Village of Eden Oaks
Oak Harbor Blvd.
St. Tammany Parish - Slidell, LA.
Sheet Title: Landscape Plan

PARCEL 14-1
OAK HARBOR COMMERCIAL, PHASE 1
SECTION 34, T9S-R14E
ST. TAMMANY PARISH, LOUISIANA

This is in response to the comments received on August 14, 2025, regarding a commercial development at Parcel 14-1 in Oak Harbor Subdivision. The comments were addressed by the following:

EXHIBIT 1
(SHEET 1 OF 2)

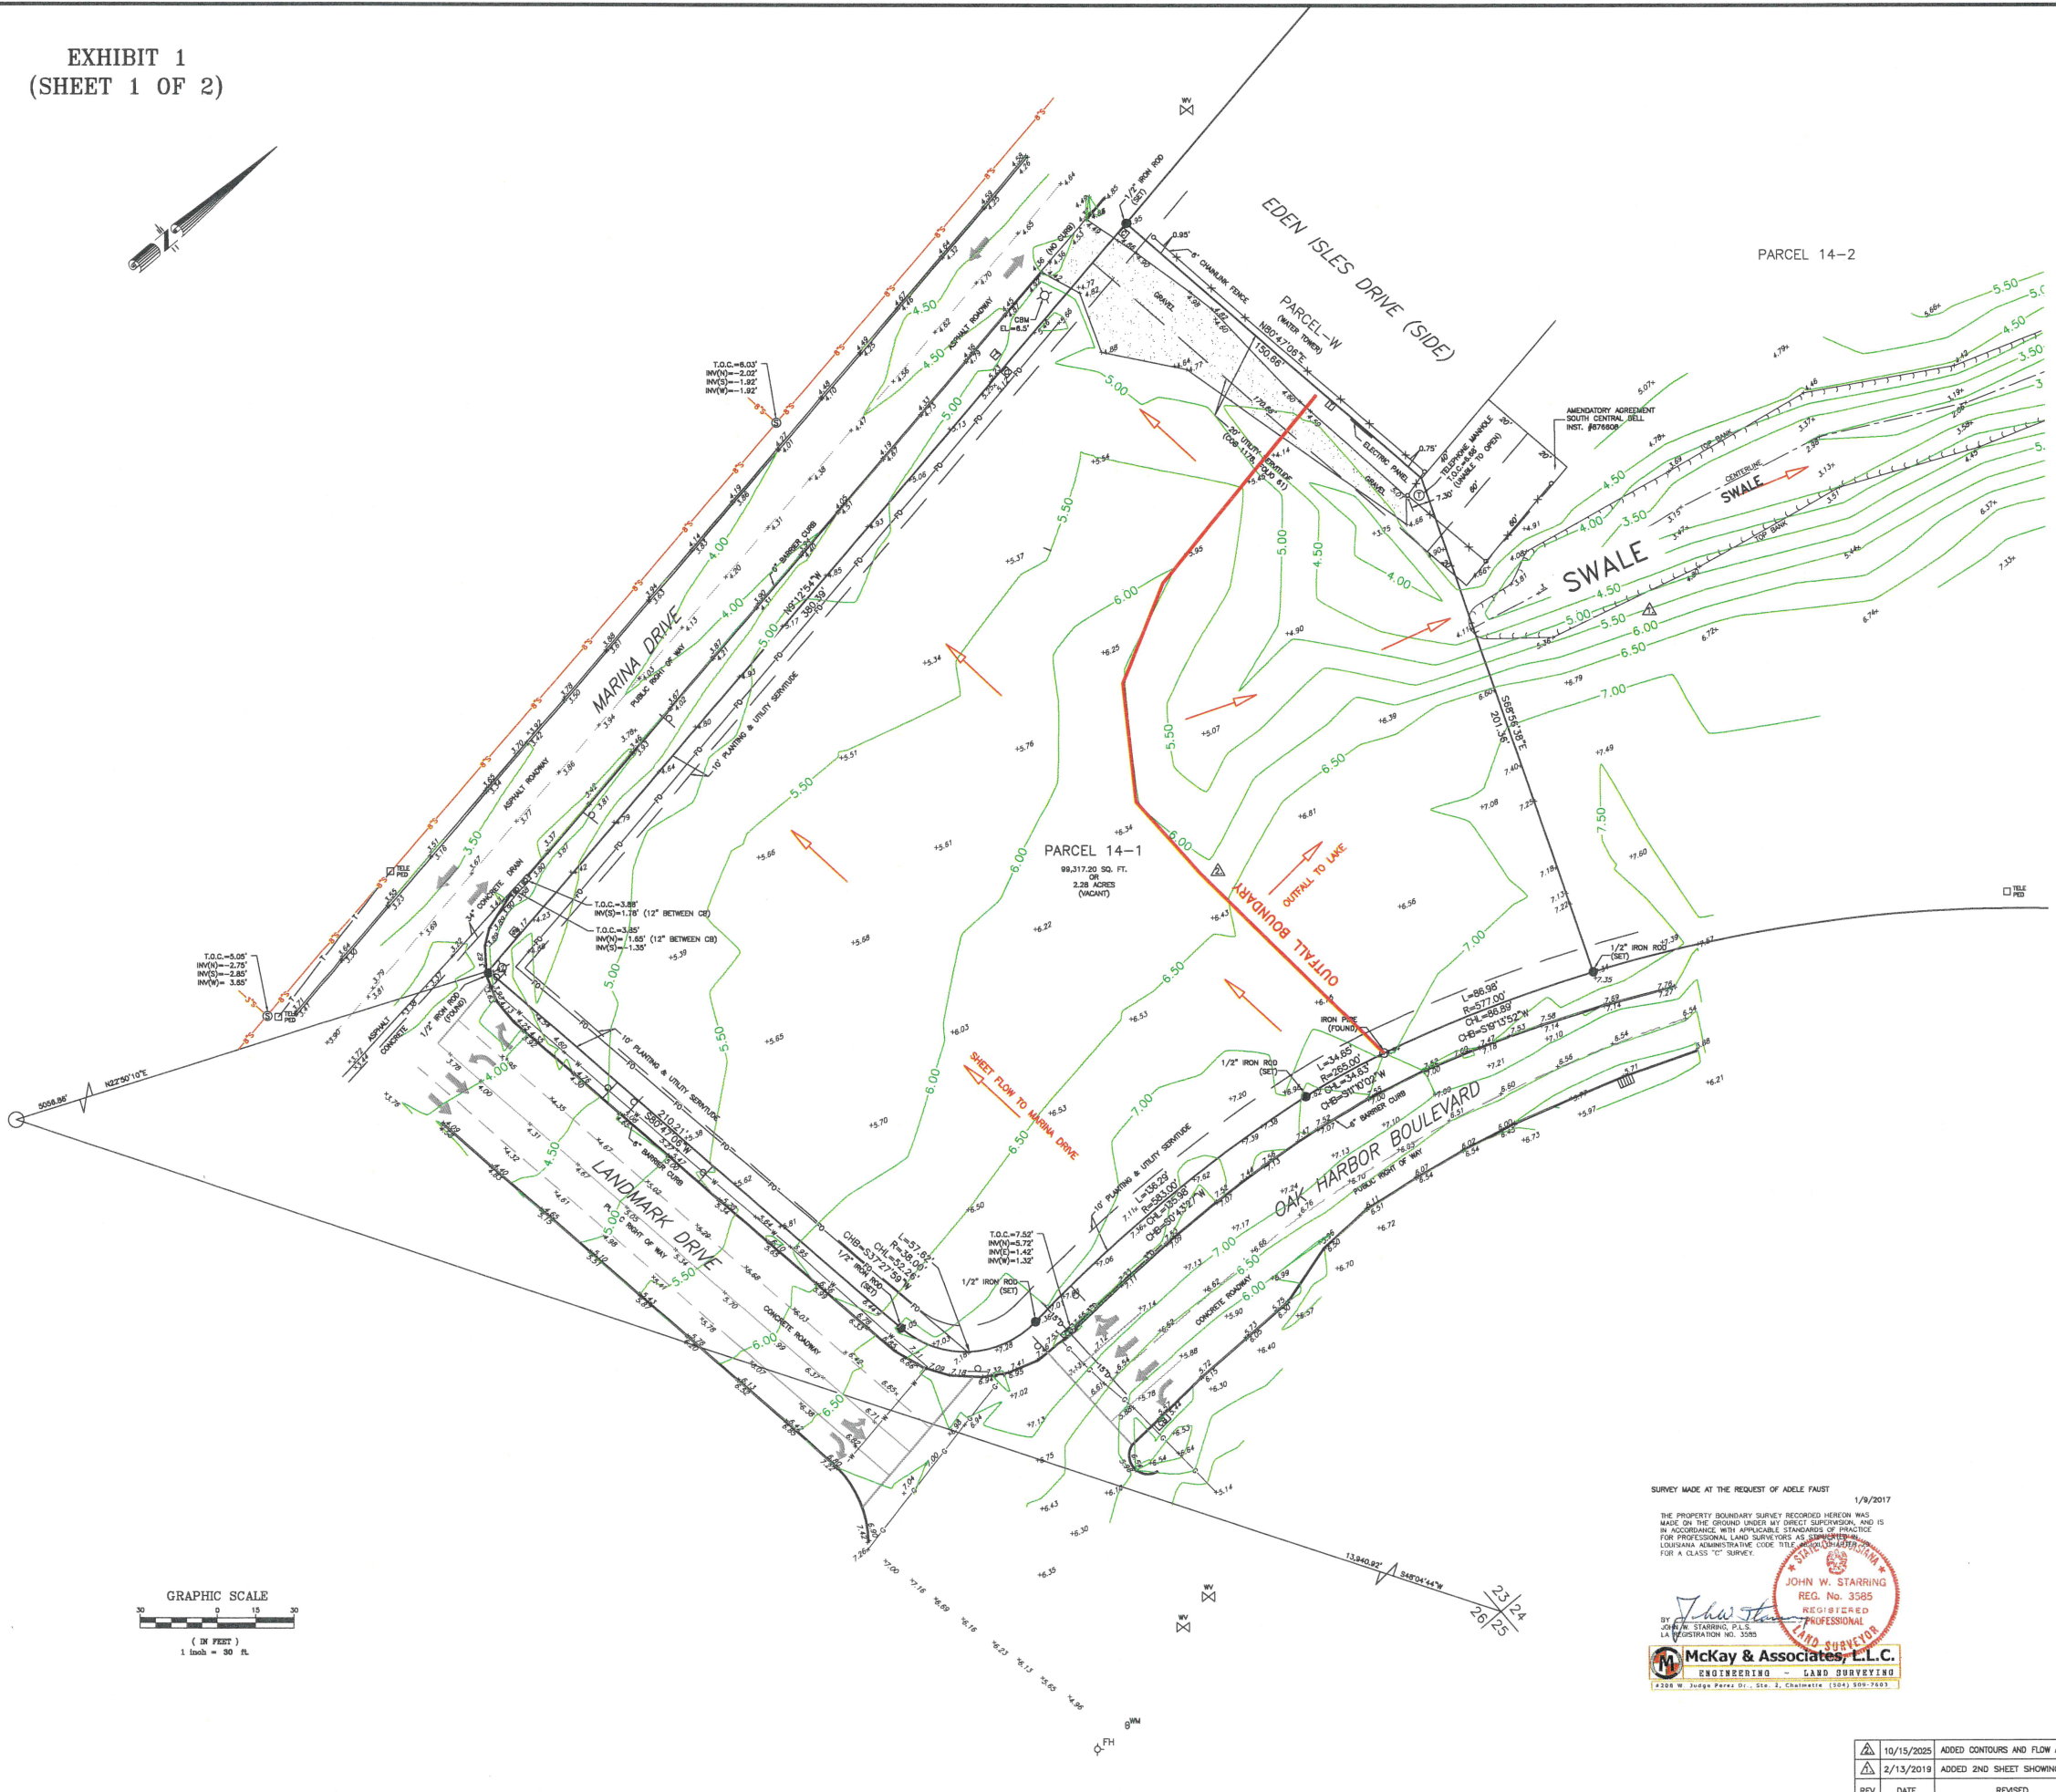
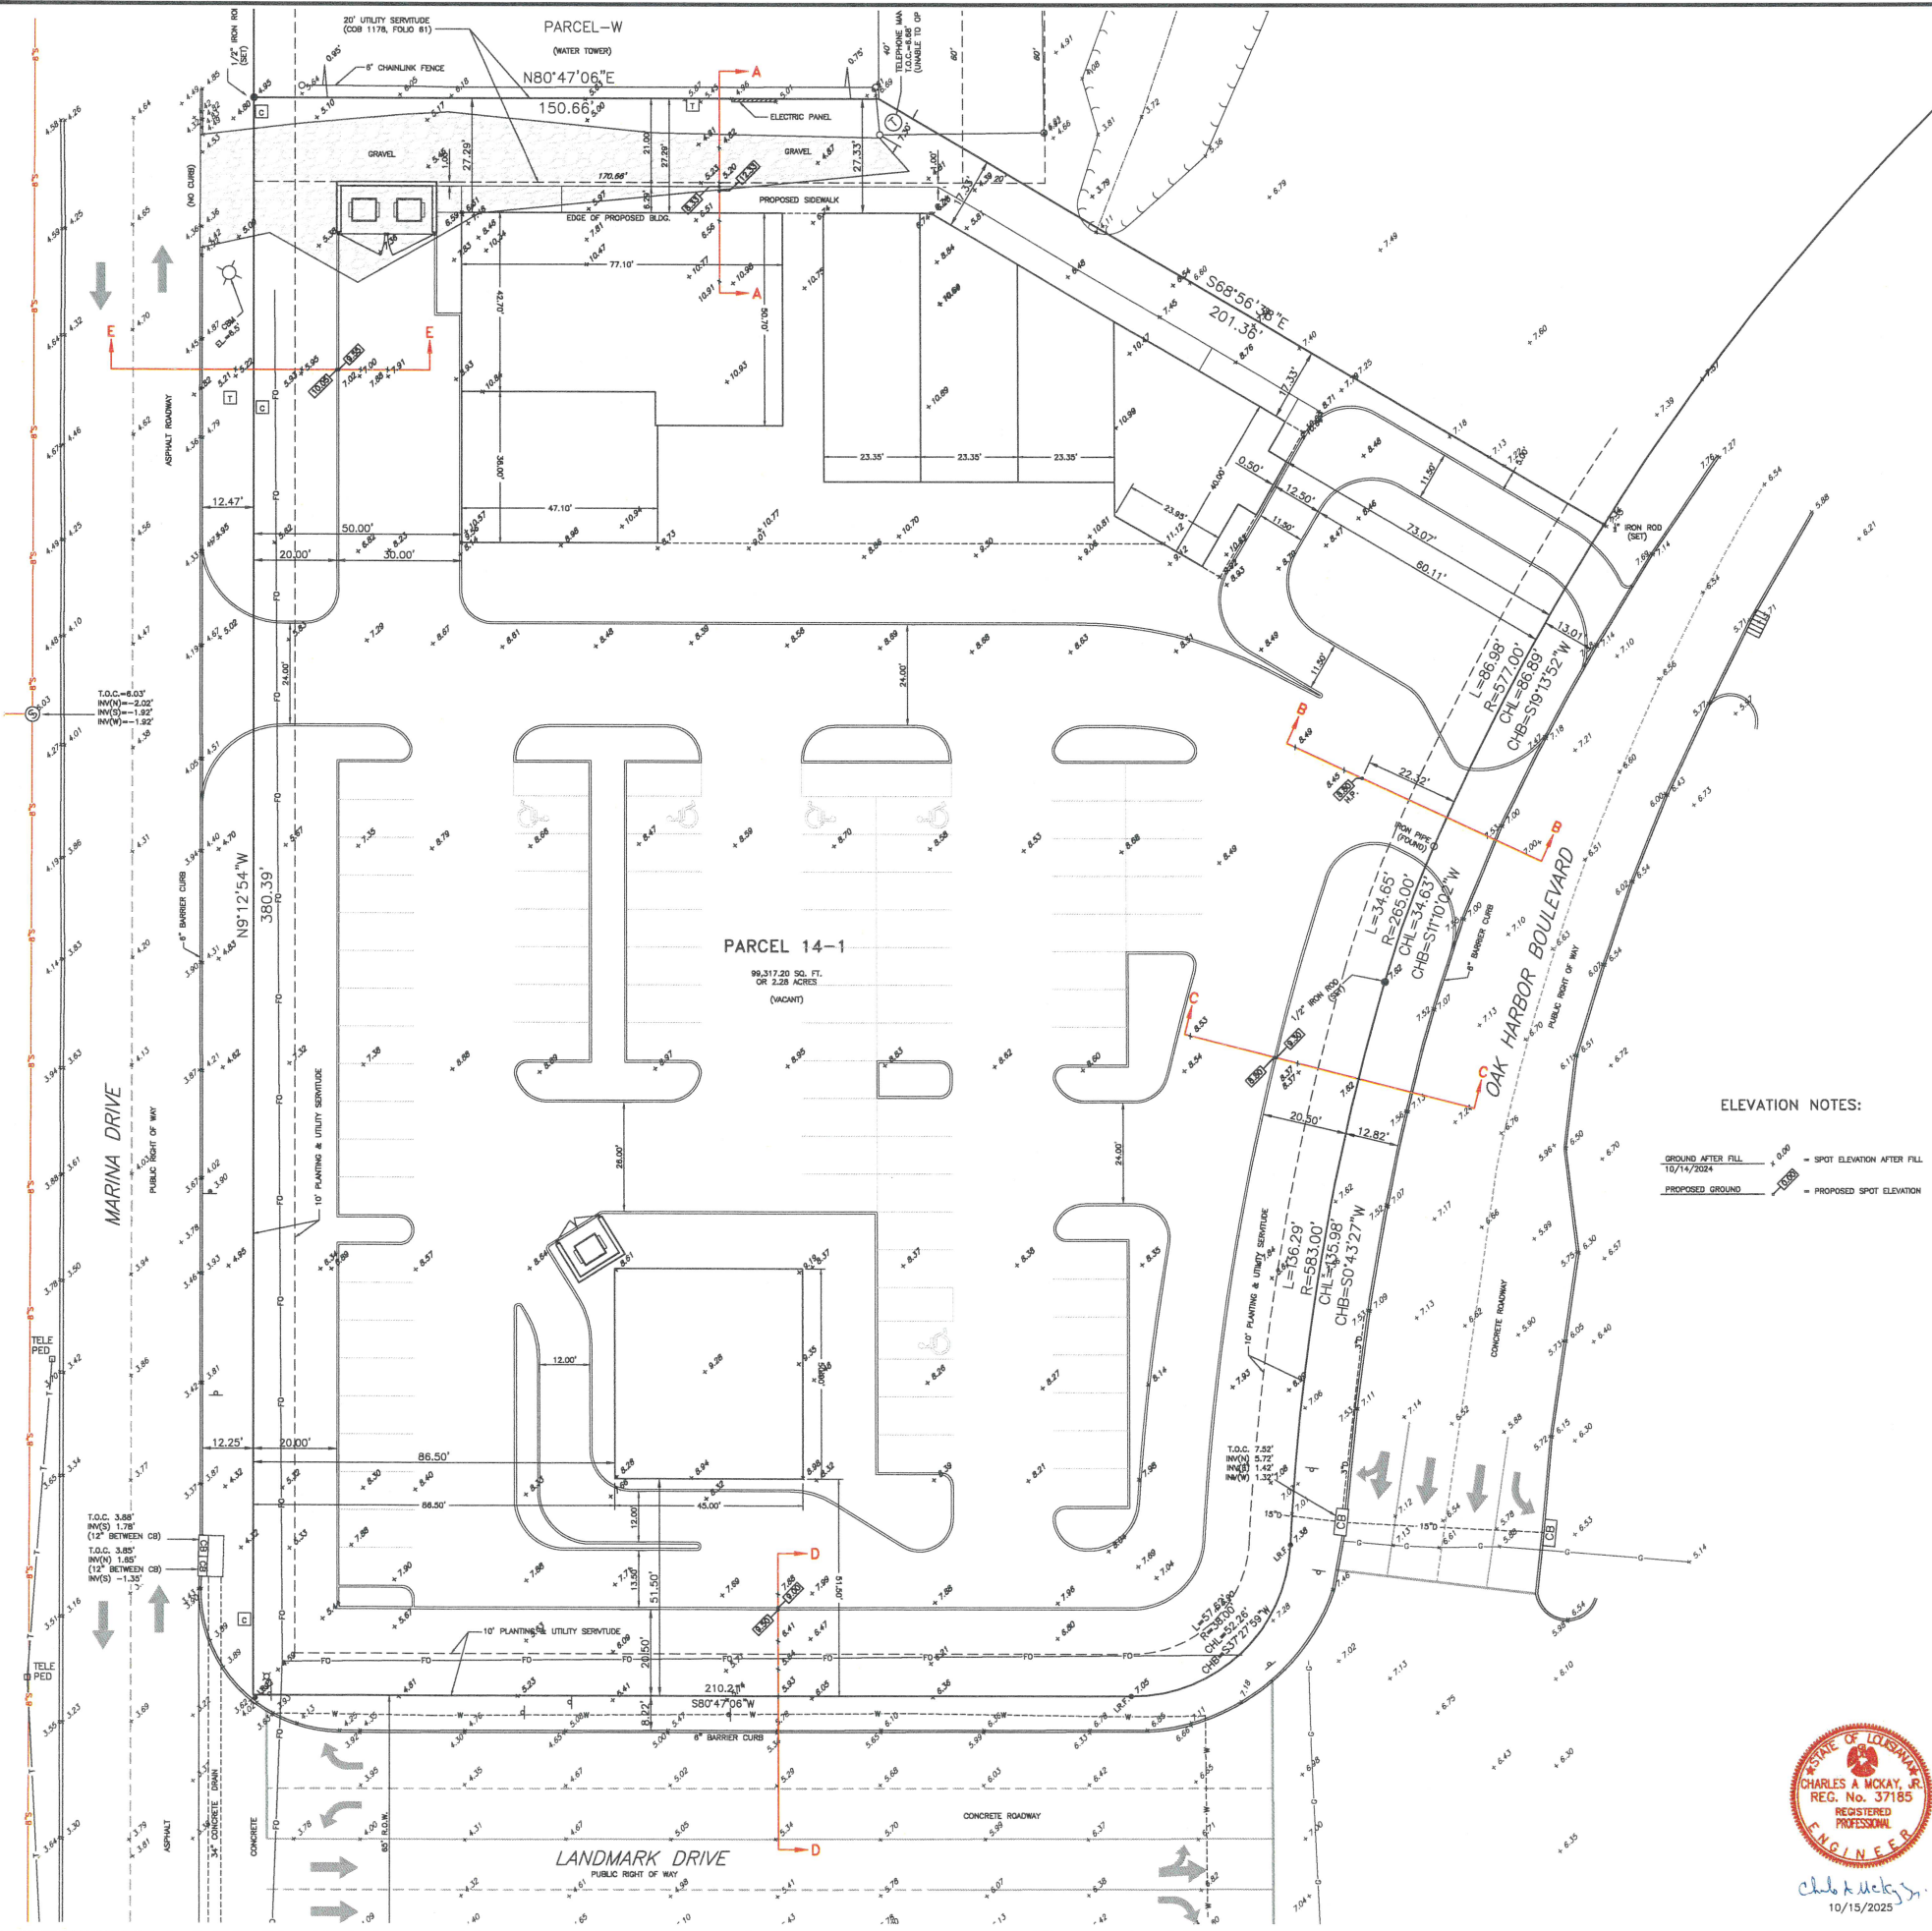
1. Drainage comment – Provide a pre-development drainage plan (existing conditions).
 - a. Refer to Exhibit No. 1 (two sheets), Topographic survey of Parcel 14-1, dated 1/9/2017, revised to include the drainage patterns and contour lines which show the majority of runoff sheet-flows west towards Marina Drive, except a portion which flows through a swale north to a lake.

2. Drainage comment – Confirm neighboring lots are not draining into proposed development as it cannot interfere or block existing drainage patterns.
 - a. Refer to Exhibit No. 1 (two sheets), Topographic survey of Parcel 14-1, dated 1/9/2017, which shows that runoff from the adjacent property flows north, away from the proposed development through a swale to a lake.
